Groundwater Remedy Phase 2A Construction, PG&E Topock Compressor Station, Needles, California

Work Variance Request #13 – Proposed Relocation of In-Vault Power and Controls Equipment to Aboveground Panels on Stanchion with Sunshade at IRZ-39

Variance Request No.: 13

FIGURE 1
Proposed Relocation of Power/Control Equipment to Aboveground at IRZ-39
 Work Variance Request #13
PG&E Topock Compressor Station
Needles, California

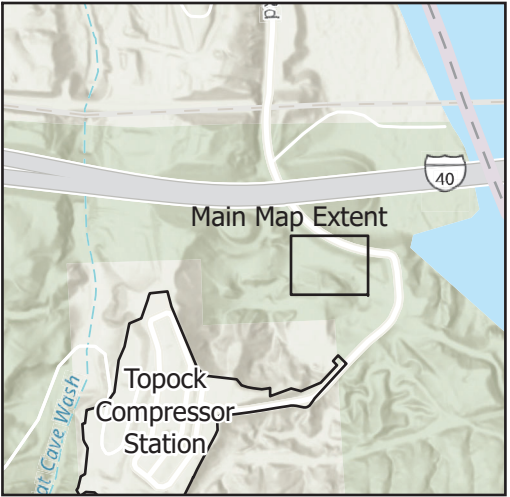
Figure 1 shows the approximate location of the new stanchion. To aid with visualization, Figure 2 illustrates the proposed new equipment. Additional details are below:

- Two new panels will be mounted on the new aboveground stanchion, one to house the relocated electrical components and one to house the relocated control equipment. A new sunshade (approximately 7 feet tall, 7 feet wide and 1ft 4inches deep) will be provided to protect the new panels.

- New conduits (2-inch in diameter) containing electrical and communication/fiber optic wires will be installed aboveground from the panels to 2-feet wide belowground trenches that connect to the well vault and the electrical pull box. Approximate total length of new conduits is 50 feet and new trench is 15 feet.

Figure 2
Illustration of Proposed New Infrastructure at IRZ-39
Work Variance Request #13

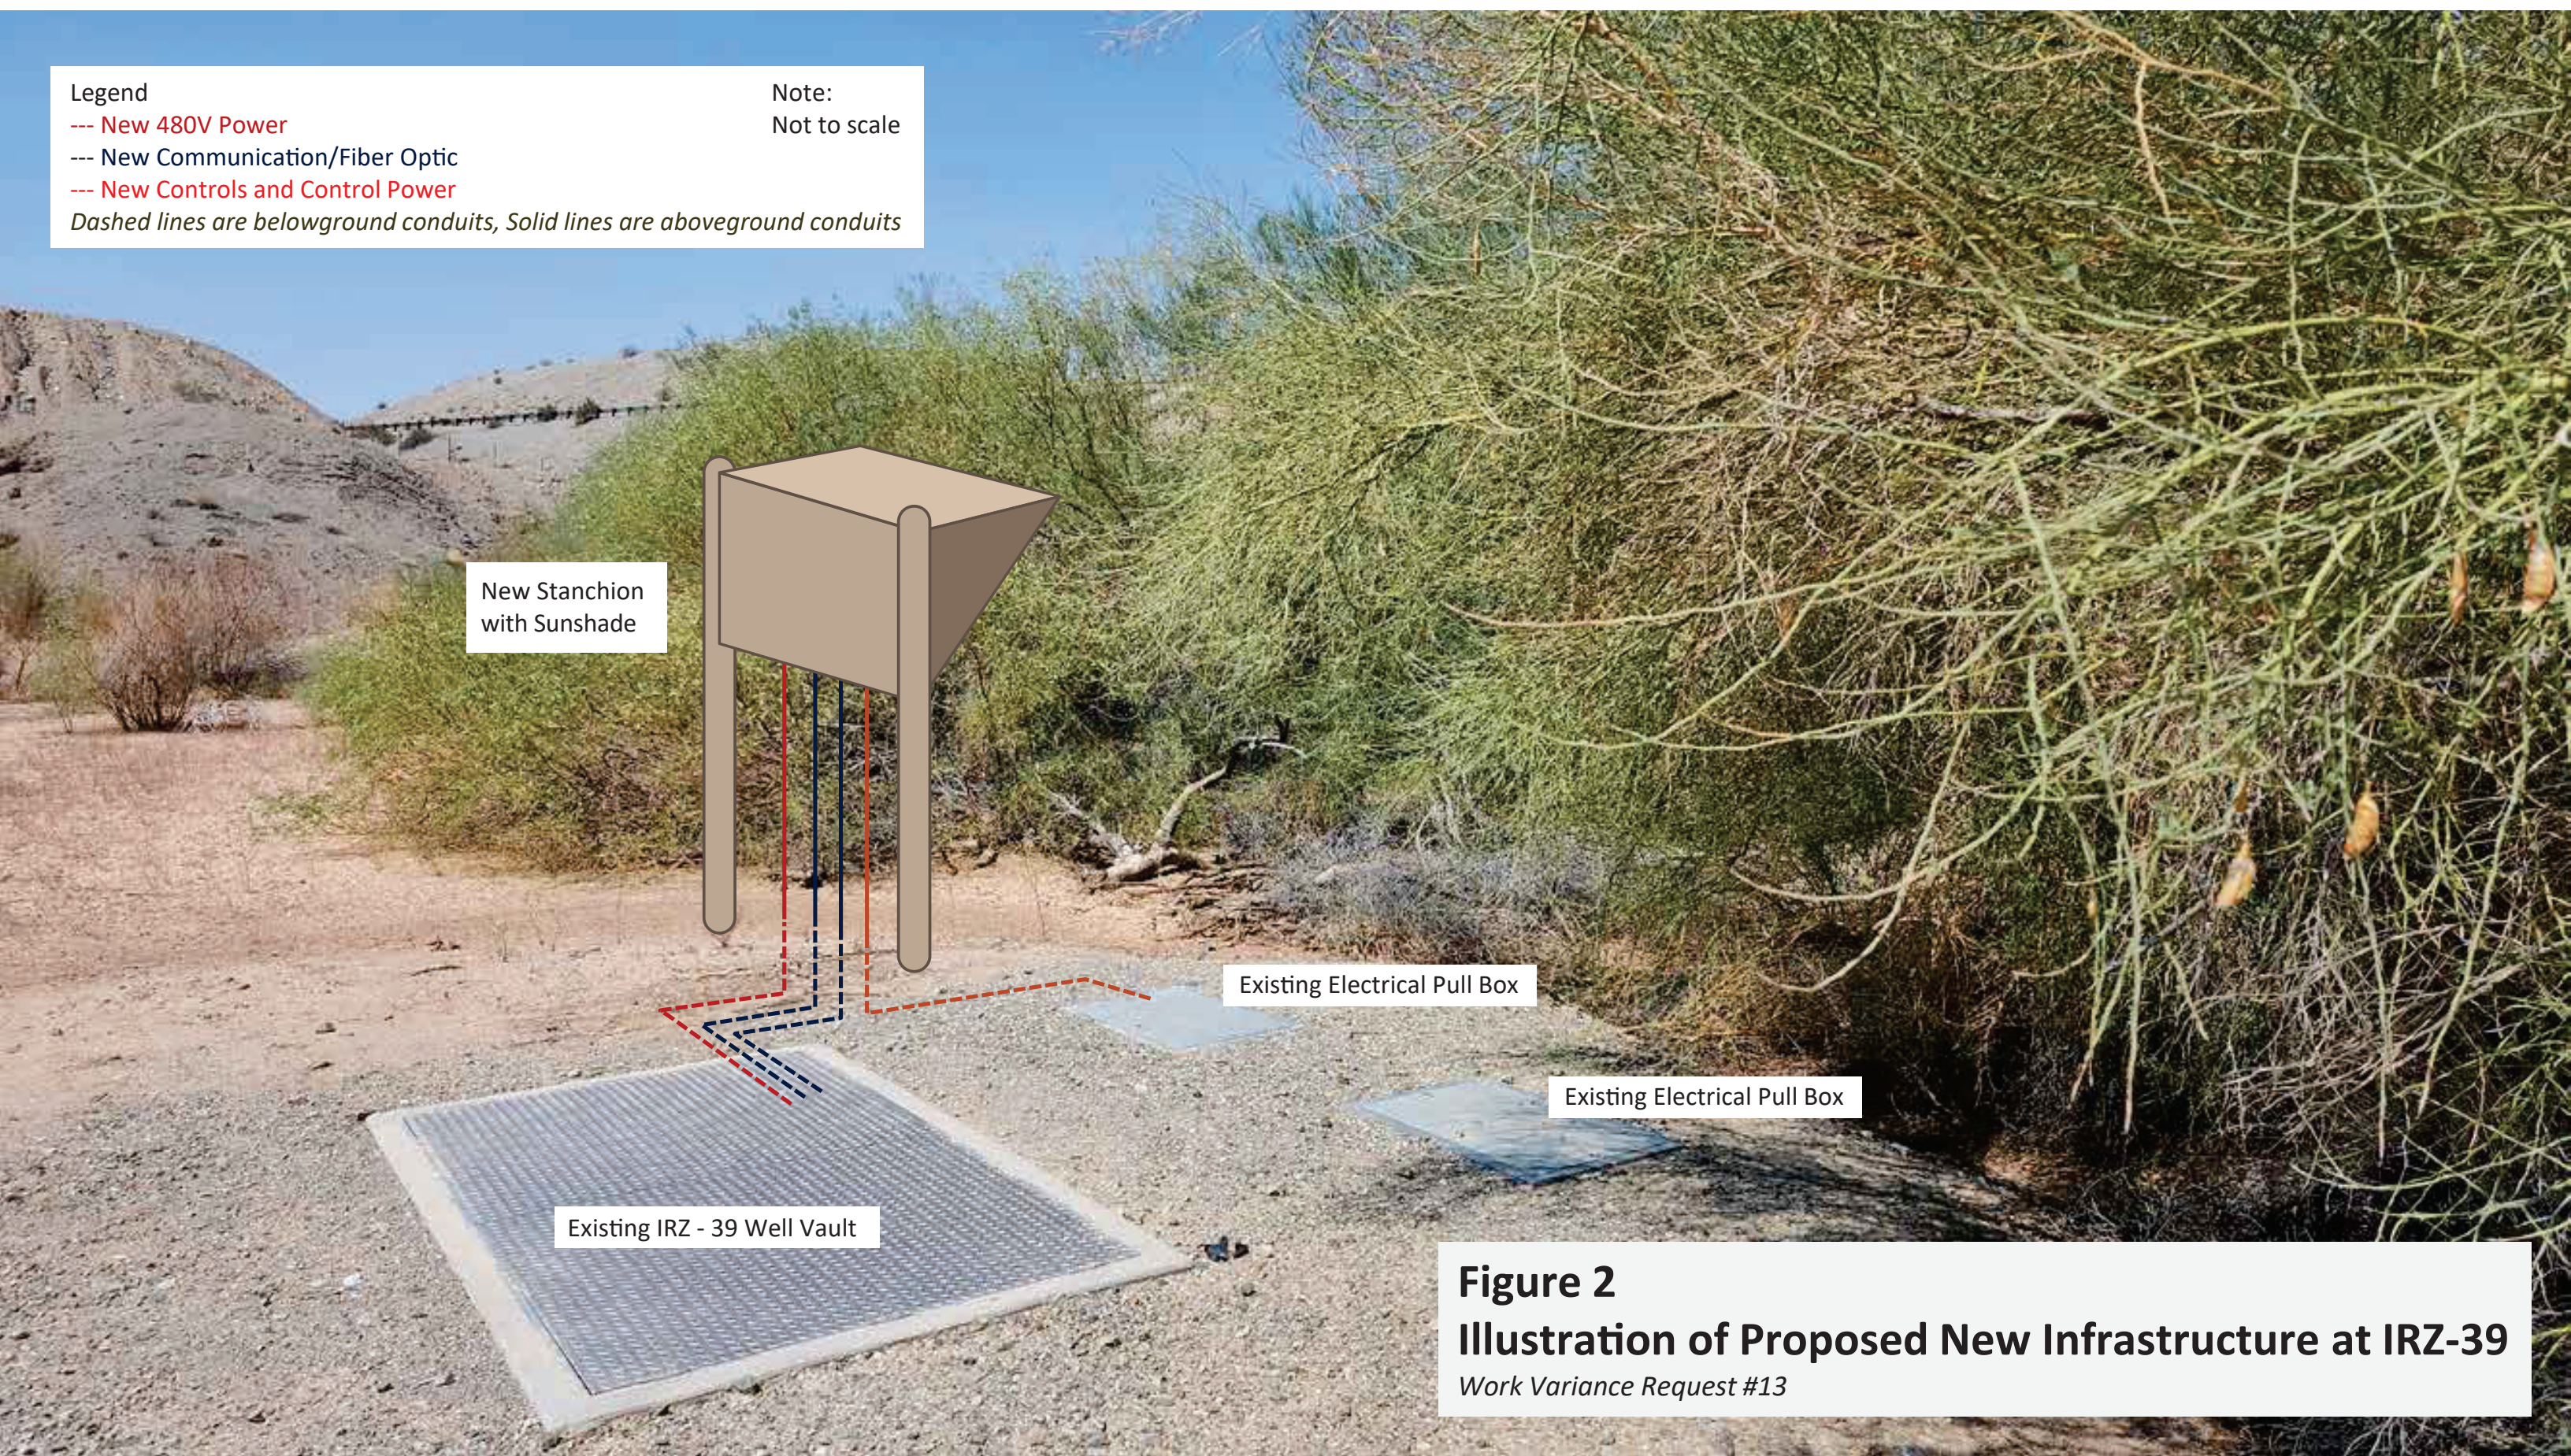
- A sunshade detail is included in the approved 2015 BOD, Drawing E-00-67, Detail 6. The proposed sunshade at IRZ-39 will, however, be installed without a rubber mat and hinge assembly over the panel door and with concrete posts rather than a larger concrete pad shown in Detail 6.
